For Bidders of
Network Cabling

ADDENDUM #4
(April 7, 2015)

UPDATE & CLARIFICATION FROM WALKTHROUGH

Re: Wiring Bid for Senior Center

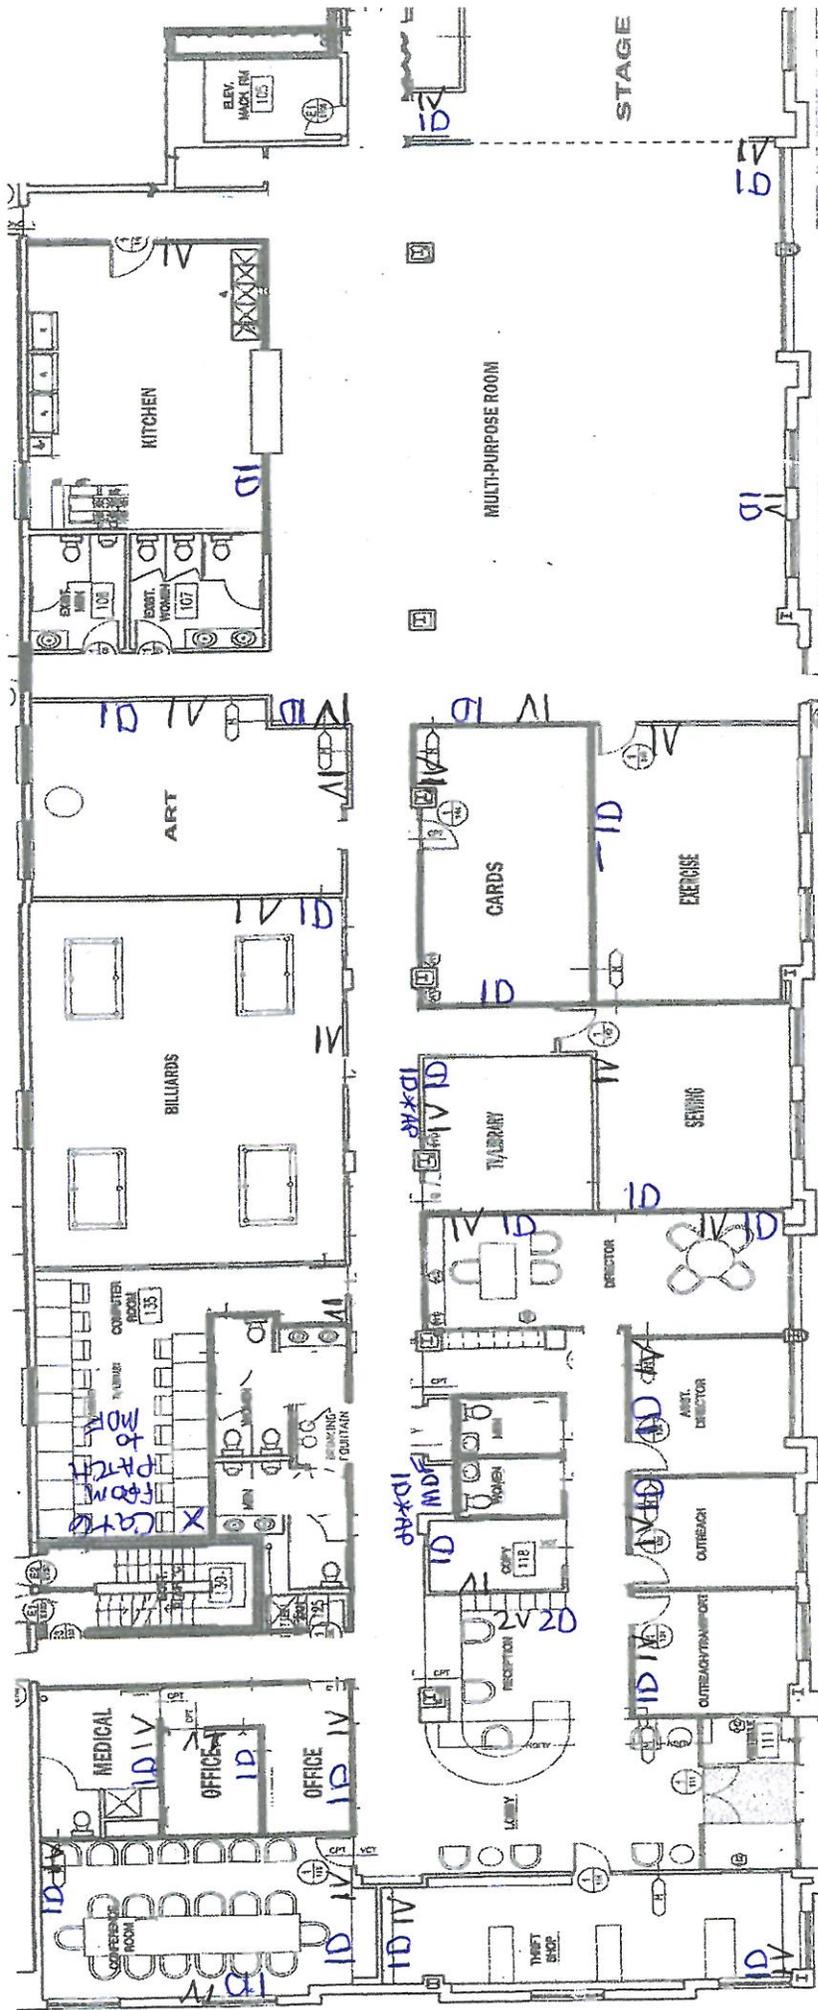
- A. Wiring Count per room
 - a. Medical
 - 1. Voice – 1
 - 11. Data-1
 - b. Inner Office
 - 1. Voice – 1
 - 11. Data – 1
 - c. Office
 - 1. Voice – 1
 - 11. Data – 1
 - d. Conference Room
 - 1. Voice-3
 - 11. Data-3
 - e. Thrift Shop
 - 1. Voice-2
 - 11. Data --2
 - f. Reception
 - 1. Voice-2
 - 11. Data – 2
 - g. Outreach/Transportation
 - 1. Voice-1
 - 11. Data-1

- h. Outreach
 - i. Voice – 1
 - ii. Data-1
 - i. Copy
 - i. Voice – 1
 - ii. Data – 1
 - J. Asst. Director
 - i. Voice-1
 - ii. Data – 1
 - k. Director
 - i. Voice-2
 - ii. Data – 2
 - l. Computer Room
 - i. Voice-1
 - ii. Data – 1 *Data run from patch panel to MDF
 - m. Outside ofMDF
 - i. Data – 1 for Access Point from ceiling
 - n. Billiards
 - i. Voice-2
 - ii. Data-1
 - o. Art
 - i. Voice-2
 - ii. Data-1
 - p. TV/Library
 - i. Voice-1
 - ii. Data – 1
 - q. Outside TV/Library
 - i. Data – 1 for Access Point from ceiling
 - r. Cards
 - i. Voice-1
 - ii. Data-1
 - s. Sewing
 - i. Voice – 1
 - ii. Data-1
 - t. Exercise
 - i. Voice – 1
 - ii. Data – 1
 - u. Multi-Purpose Room
 - i. Voice-4
 - ii. Data – 4
 - v. Kitchen
 - i. Voice-1
 - ii. Data-1
 - w. Stage
 - i. Voice – 1
 - ii. Data – 1
- B. Total wiring count for Senior Center
- a. Voice- 31
 - b. Data – 31
 - c. Total Line are 62

C. A 12 strand fiber run in an innerduct conduit is needed from the basement demarcation to MDF.
